Mottagare: Kontrollanter, kontrollantelever, klubbar, MC Norden	Datum: 2003-09-26	Bilaga SB1/2003/ TECH240	Blad nr: 1 av 1
Fastställt av MK: 2003-09-26	Ersätter:	Ärende: Materielmeddelande nr. 4/03	
		Utfärdare: SFF Materielkommitté (MK)

Service-bulletin SB1/2003/TECH240, daterad 28 juli 2003, från Parachutes de France.

TITLE: MAXIMUM OPERATING LIMITS TECHNO 240

STEP B - SLIDER REPLACEMENT:

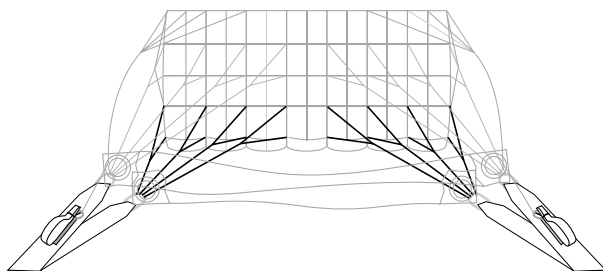
- 1** Remove the original slider of canopy.
(P/N:P2008040060, identification stamp: 64-42-13)

Install the slider provided in retrofit kit.
(P/Nf: P2008036600, identification stamp: 57-74 CR)

front lines assembling

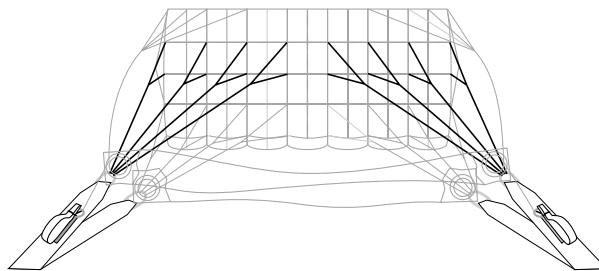
- 3** Check the canopy connection to risers with the following drawings:

Steering lines assembling

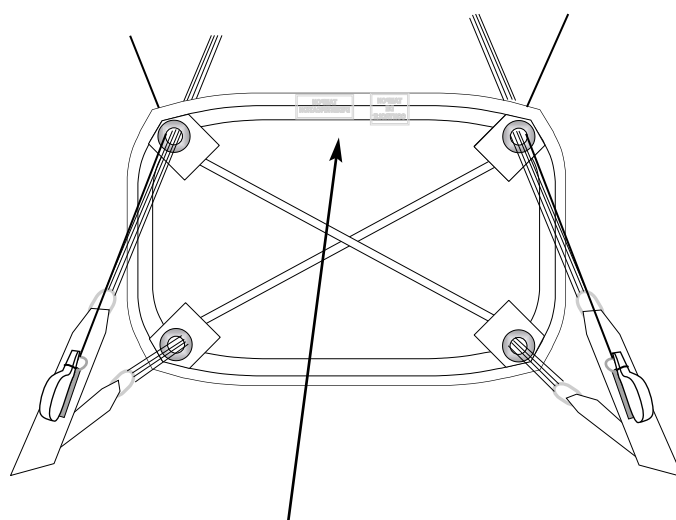
Check of slider position
The identification stamp should be placed between
rear risers toward top direction.
(intrados side)
